Memorandum

RE: SP-01-2024, Lincoln Corner Plaza II Revisions, SR 30, C-1 Zoning

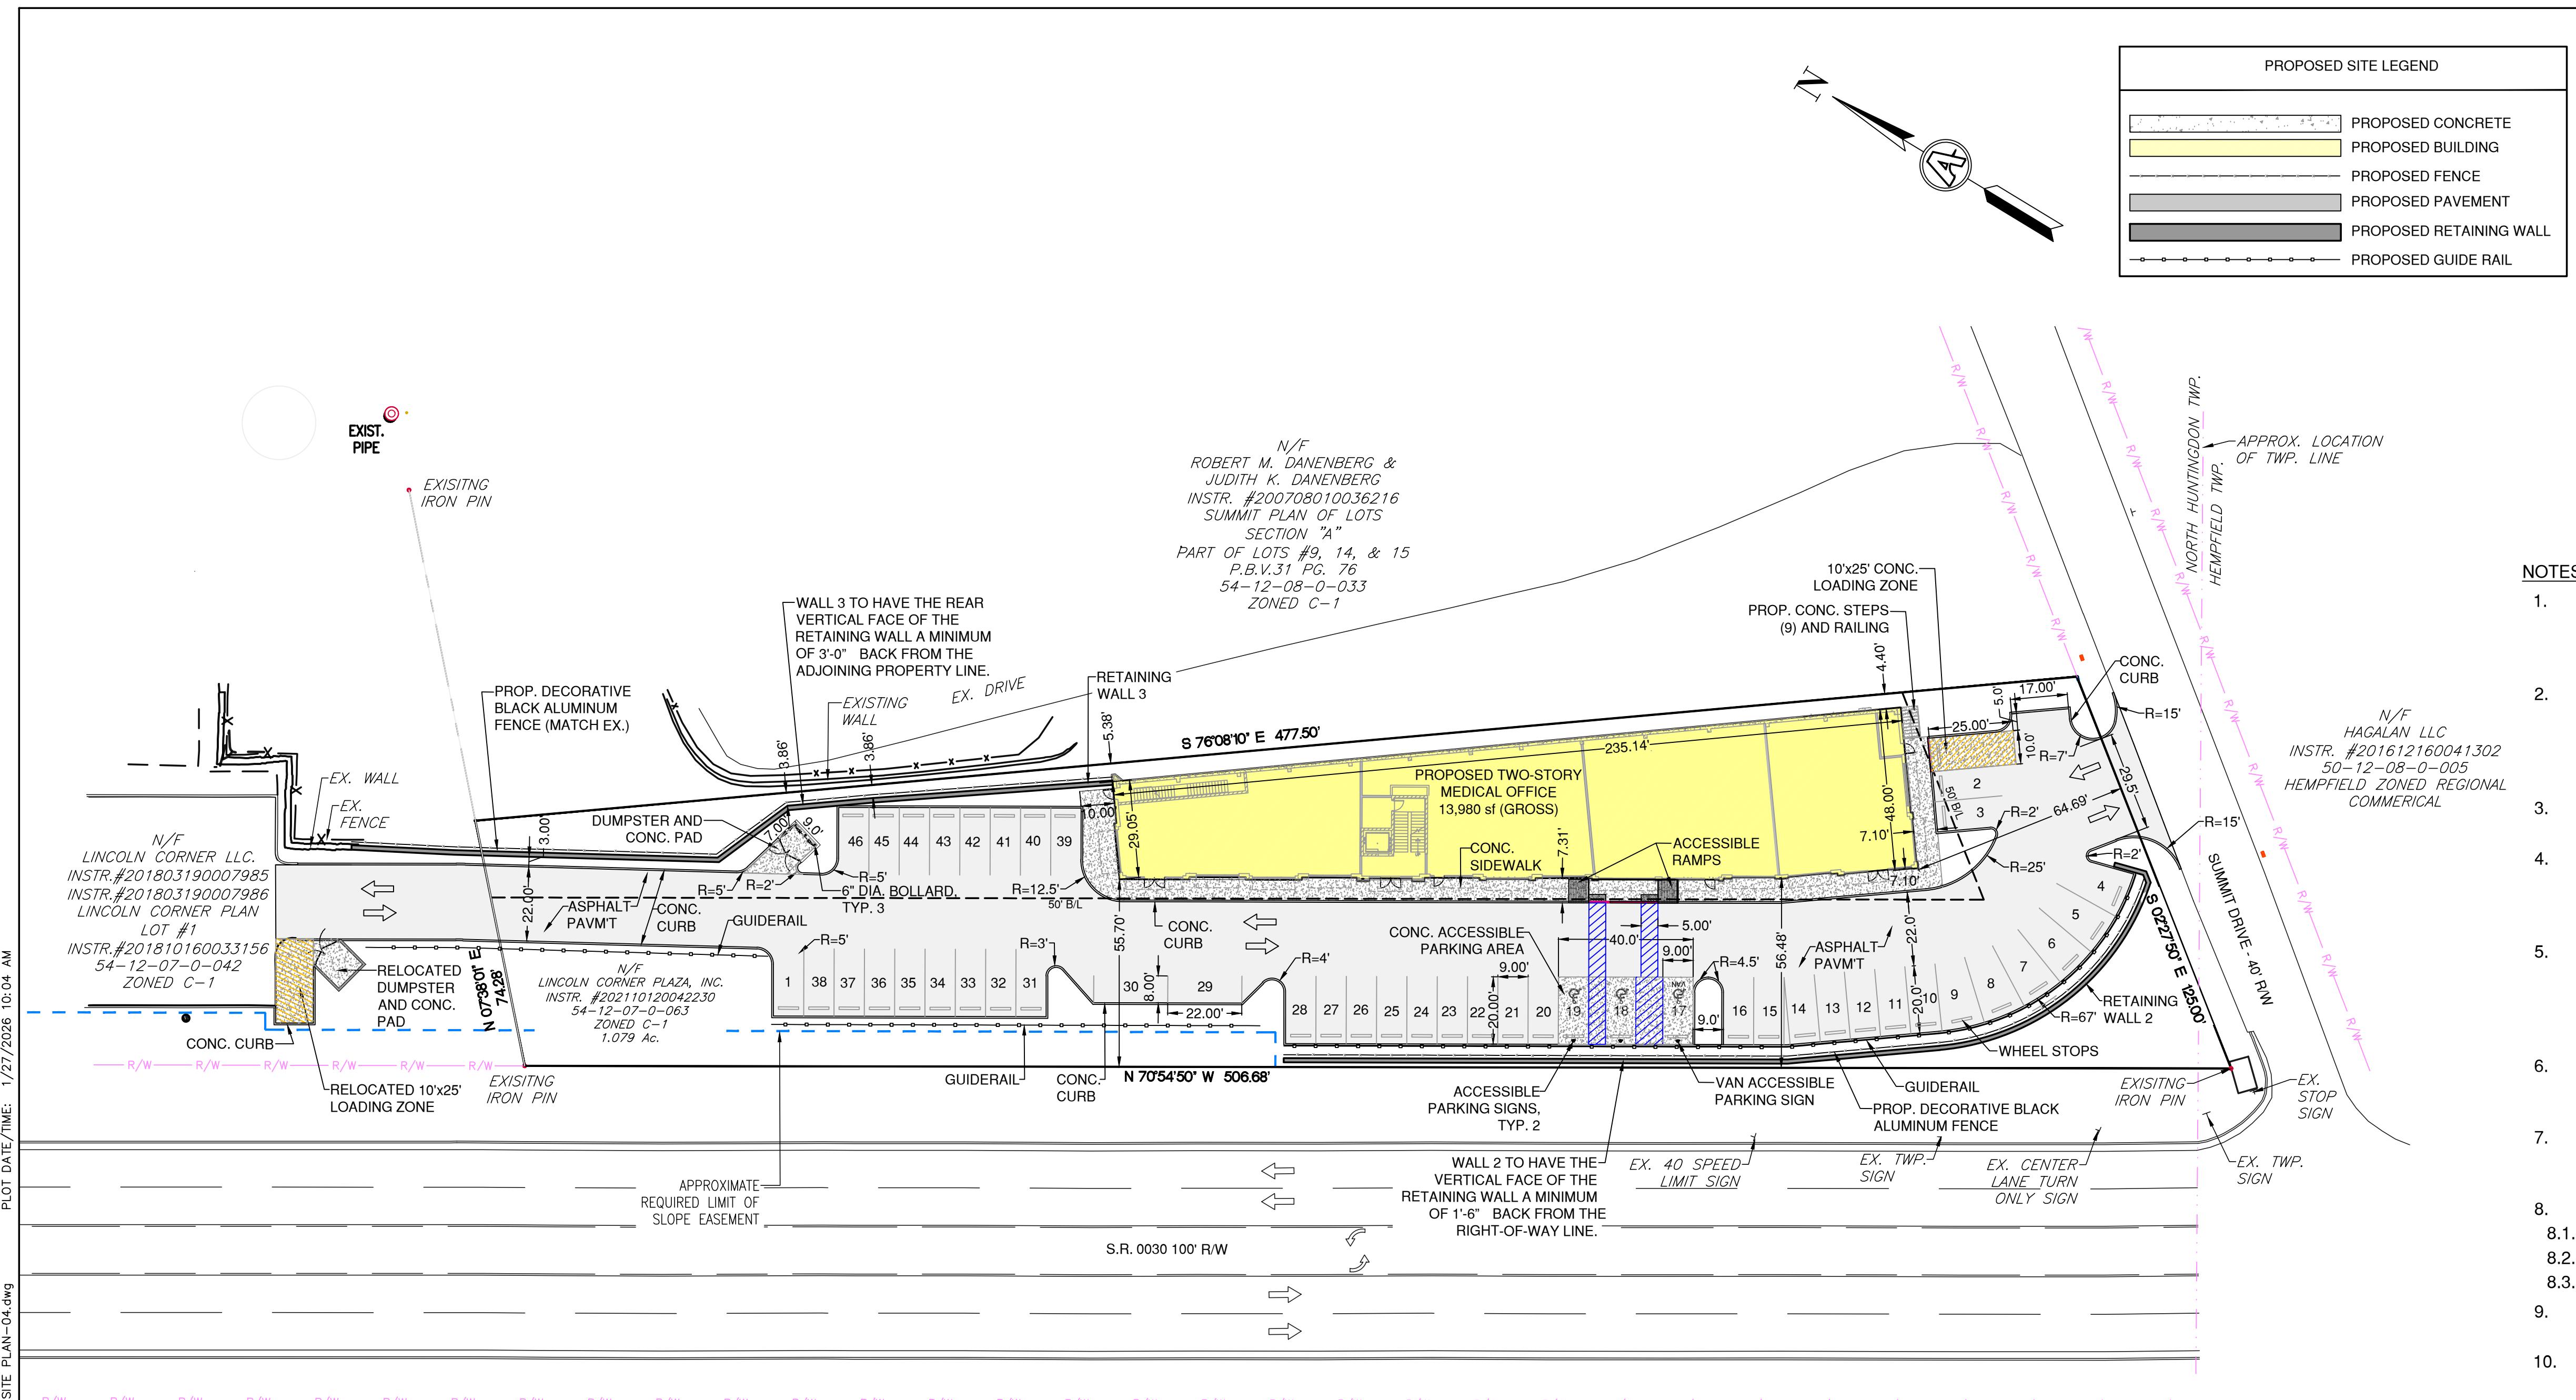
Last July, Lincoln Corner Plaza, Inc. was approved to build a 9,308-sf one-story office building. With the current change request, they are proposing to build a two-story building within the same footprint, and the square footage will increase to 13,980 sf. Since the rear wall of the building will act as a retaining wall, the height of that wall will increase when the building is expanded to two-stories.

The impervious area of the site is not changing; therefore, the stormwater management plan will not be affected. Two other minor details are the relocation of parking space #1 from the eastern side of the building to the far southwestern corner of the parking lot. The other minor item is the removal of a small retaining wall on the northeast corner of the site. Everything else will stay consistent with the last approval.
